Item Name: Upper Cutter Assy

ENGINEERING CHANGE NOTICE NO.

DWG NO. 646.3300

DWG TITLE: UPPER CUTTER ASSY

SHEET 5 IS:

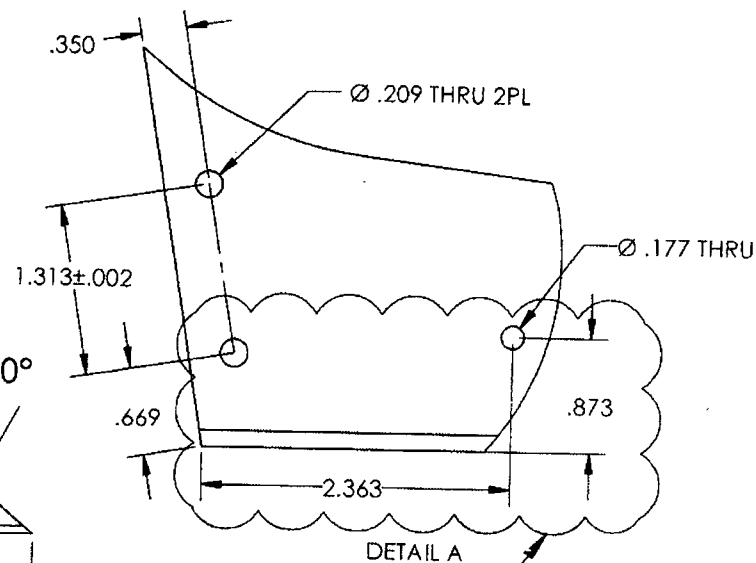
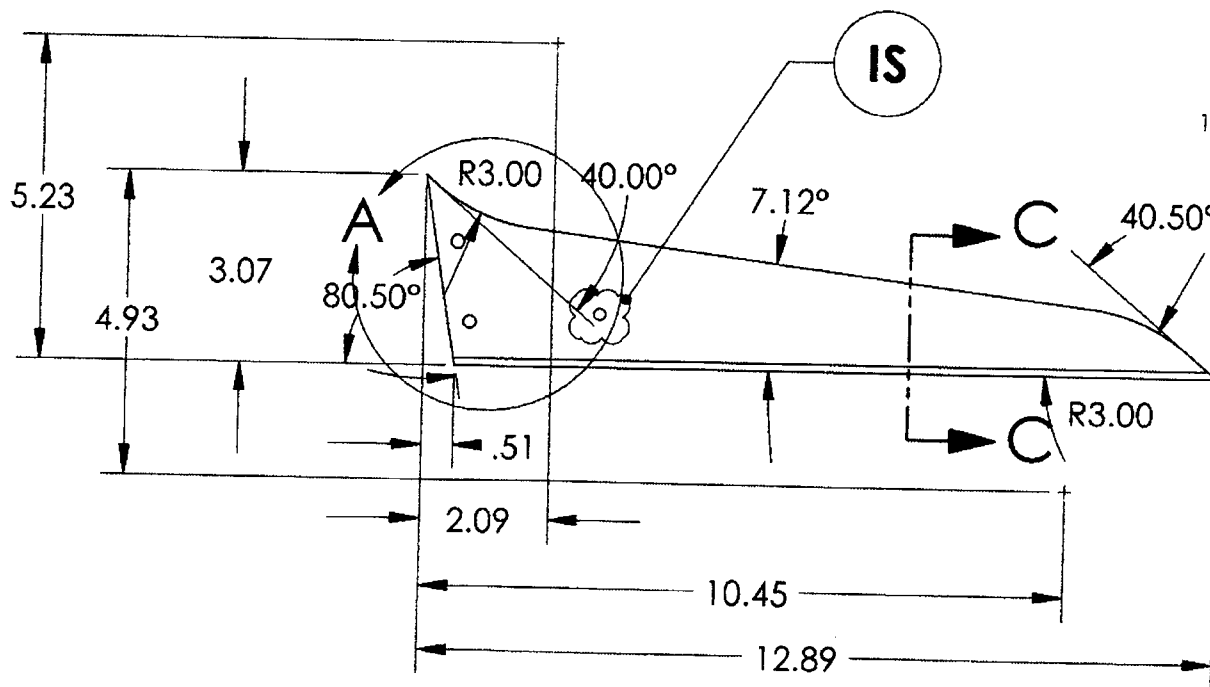
REASON: ADDED HOLE DIMENSION TO 646.3313.

SHEET 4, ZONE B8 IS:

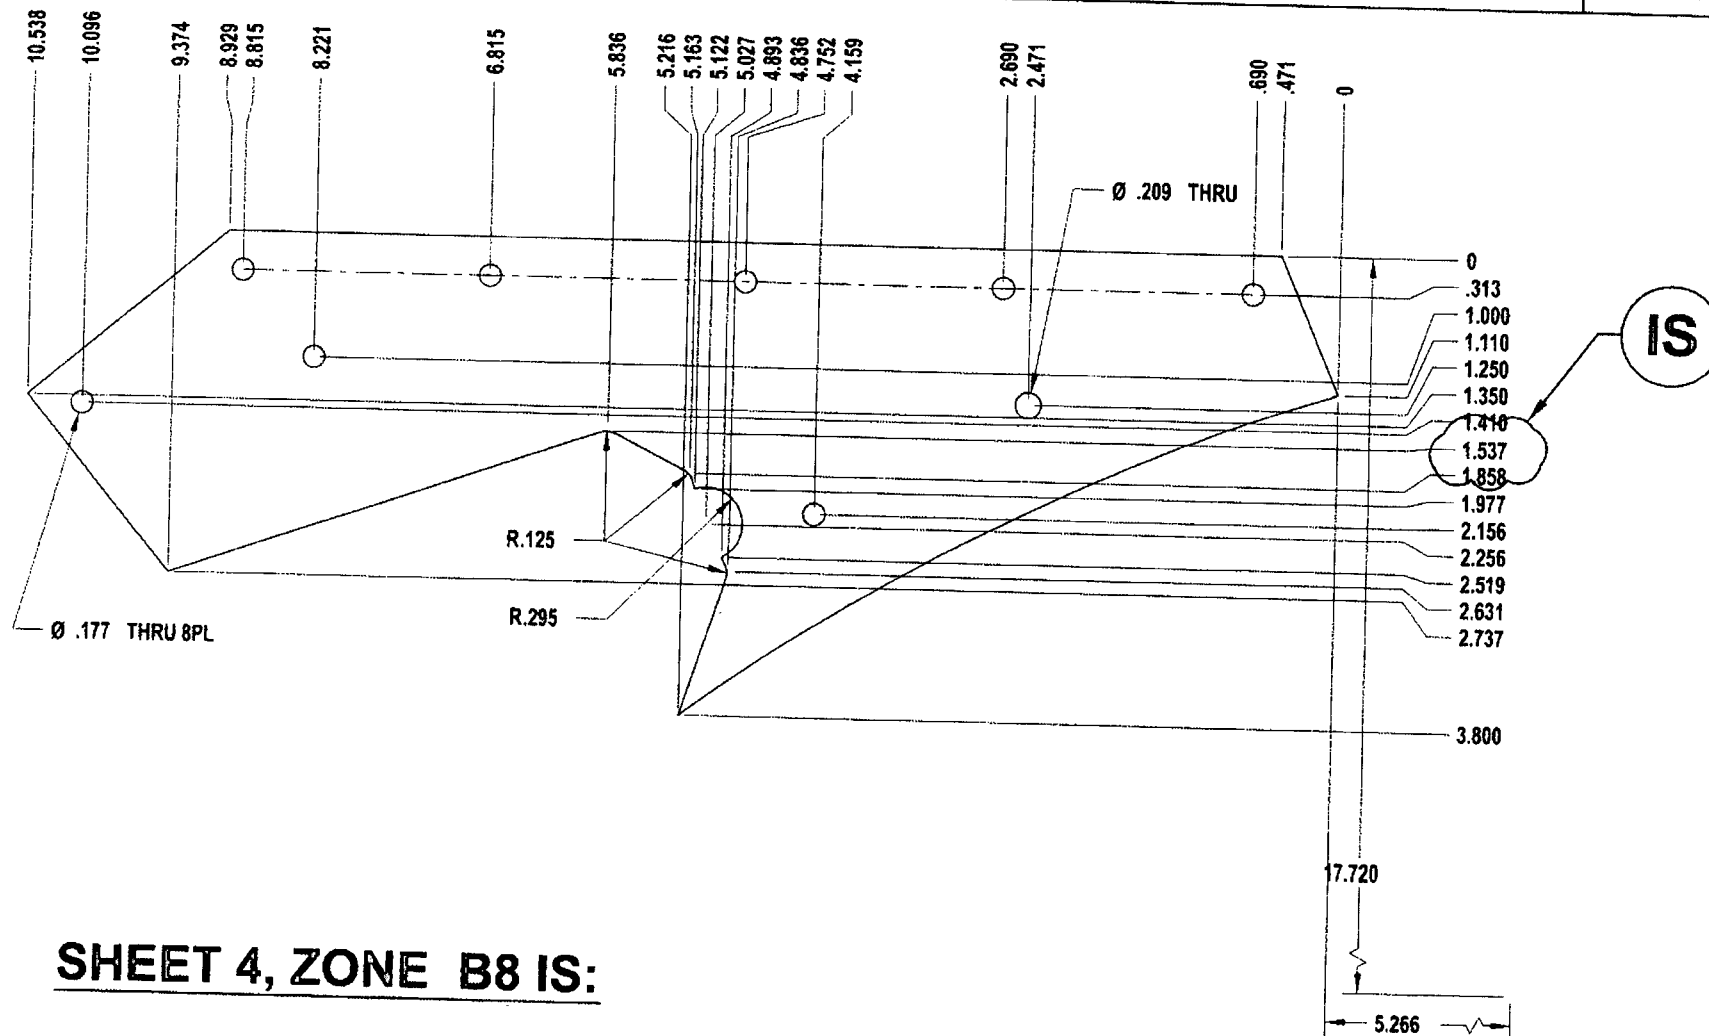
REVISED ORDINATE DIMENSION.

SHEET 1, VIEW 646.3301, IS:

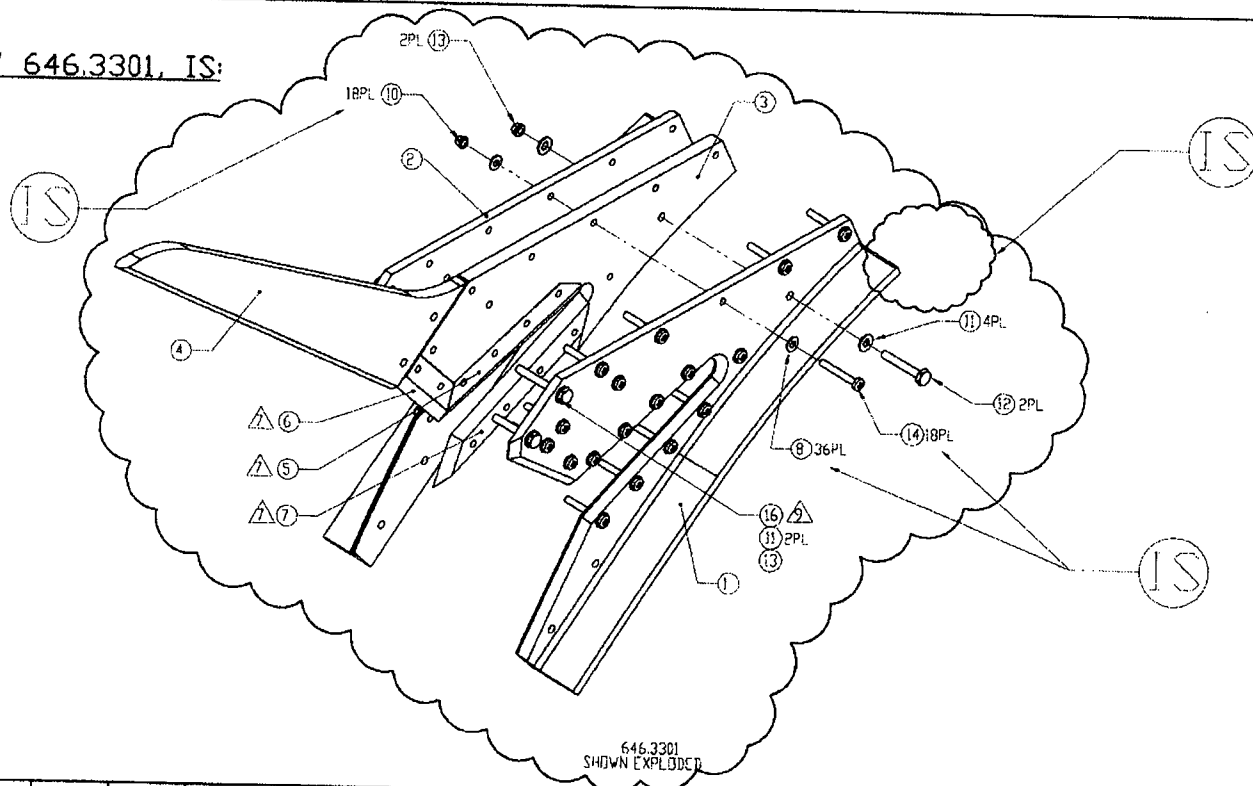
ENGINEERING CHANGE NOTICE NO.		02196		SHEET 1 OF 2	
DWG NO.	646.3300	REV: N/C	PREPARED BY	S. HUFF	DATE: 01/05/09
DWG TITLE:		UPPER CUTTER ASSY			
APPROVED BY:	ENGR <i>[Signature]</i>	MFG	<i>[Signature]</i>	QC	88
REASON: REMOVED RIVETS IN FAVOR OF ADDITIONAL SCREWS					EFF: NEXT ORDER
TRANSACTION CODES (TC): A-ADD C-CREATE R-REVISE D-DELETE

14	R	601.2765	18	SCREW	MS27039-0819
10	R	601.1541	18	LOCKNUT	MS21042L08
9	D	601.2766	3	RIVET	MS20470AD5-18
8	R	601.2764	36	WASHER	NAS1149FN832P
			3301		
F/N	TC	PART NUMBER	QTY	DESCRIPTION	MATERIAL/SPECIFICATION
DOCUMENTS EFFECTED:					
				CHANGE CATEGORY	DER REVIEW REQUIRED
				☐ MAJOR ☒ MINOR	☐ YES ☒ NO
